PLAN-004690

Proposal: Single storey side and front extension following demolition of existing porch, garage and study.

Site: 6 Selsey Close, Hayling Island, PO11 9SX.

APP/13/01094

Southern Water MapGuide Browser

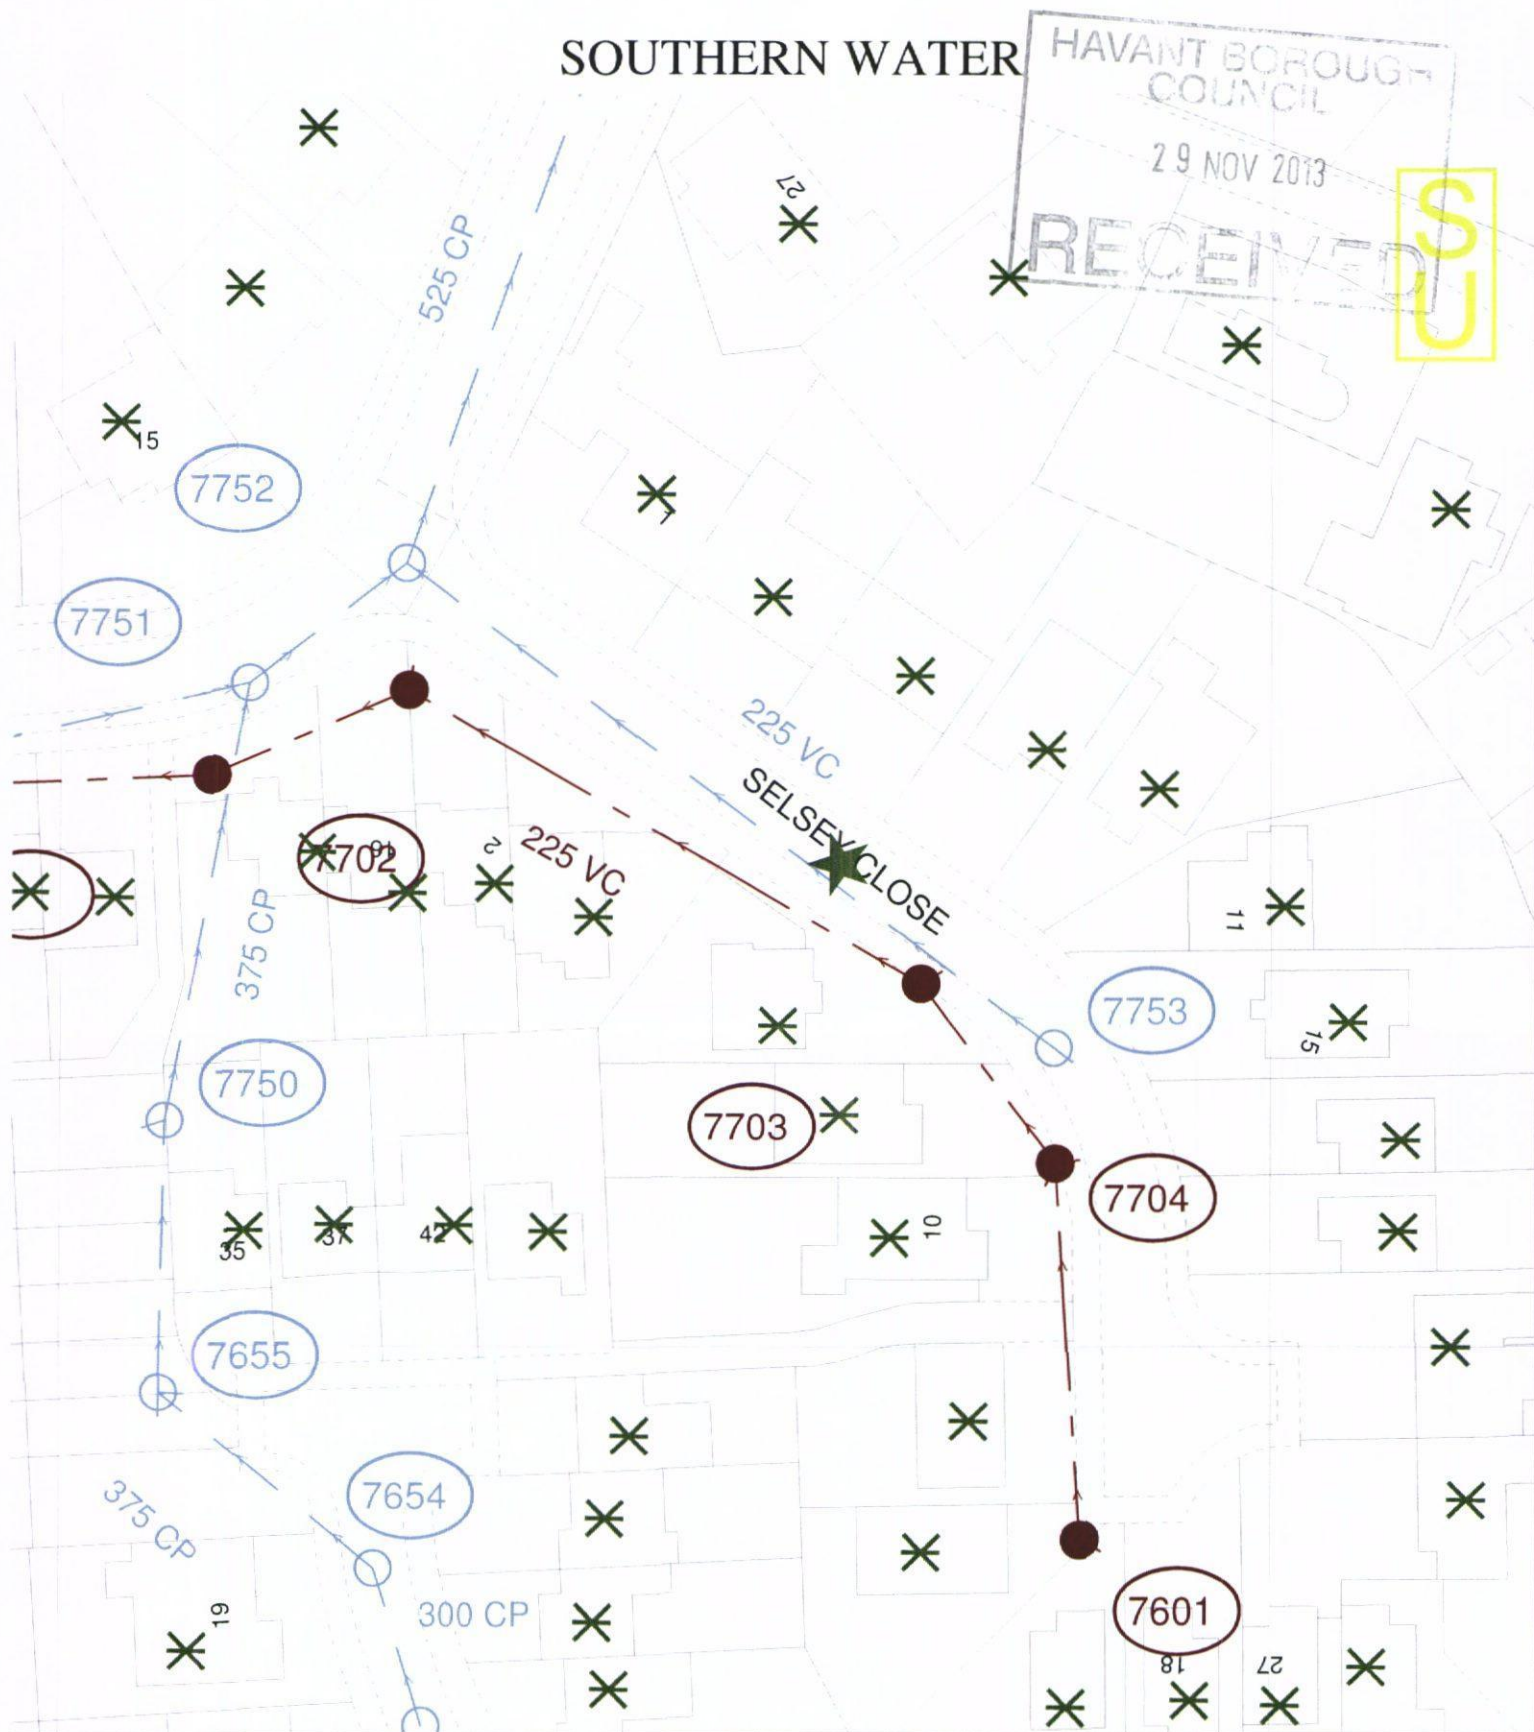
Please find attached a plan of the sewer records showing the approximate position of a foul sewer within the site. The exact position of the foul sewers must be determined on site by the applicant before the layout of the proposed development is finalised.

- No development or new tree planting should be located within 3 metres either side of the centreline of the public sewer.
- No new soakaways should be located within 5m of a public sewer.
- All existing infrastructure should be protected during the course of construction works.
